Incredible Fashions Ltd.

Karol Surichala, Mouchak, Kaliakoir, Gazipur.
(24.0486433N, 90.2678078E)

15th March 2015

Observations

**Drawings do not represent as constructed
condition at various locations**

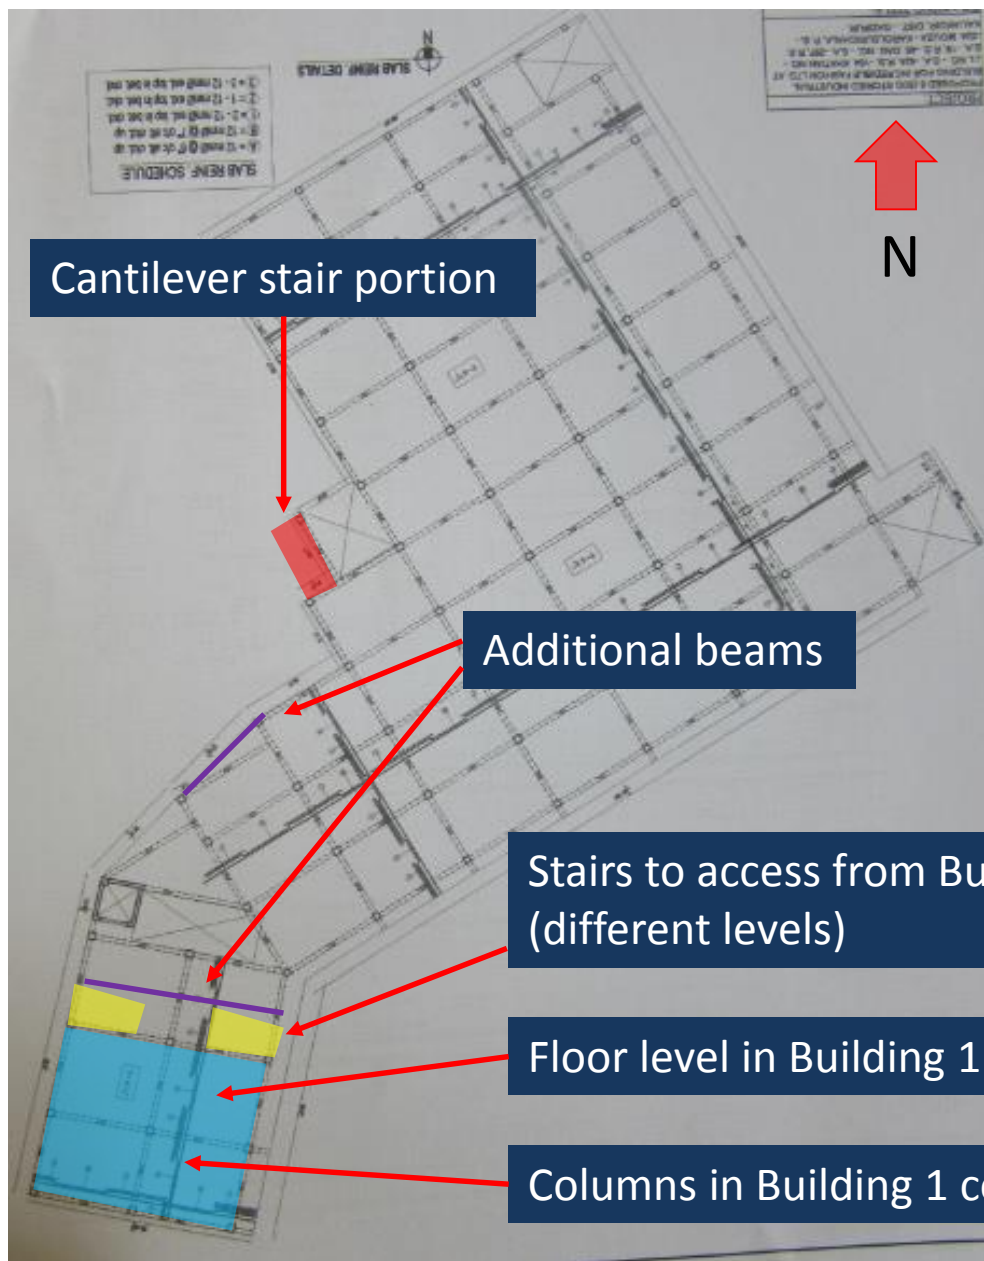
Cantilever stair portion

Additional beams

Stairs to access from Building 2 to Building 1
(different levels)

Floor level in Building 1 different level to Building 2

Columns in Building 1 constructed larger than drawn

Item No.	Observation	Recommended Action Plan	Recommended Timeline
1	Building 2 Uncontrolled loading	Loading plans showing allowable imposed (live) loading on each floor to be developed taking account of the structural capacity of columns, beams and slabs.	6-months
2	Building 2 Uncontrolled loading	Implemented floor loading in accordance with loading plans.	6-months
3	Building 2 High column stresses at completed building height	Factory Engineer to review design, loads and columns stresses for building when completed to full height taking account of existing cylinder strength data for Columns (supplemented with additional cores to be taken from ground floor columns if necessary)	6-months
4	Building 2 High column stresses at completed building height	Amend allowable imposed loads if required.	6-months
5	Building 1 and 2 Discrepancies in drawings	Factory engineer to update drawings to correspond with the as-constructed arrangement	6-months
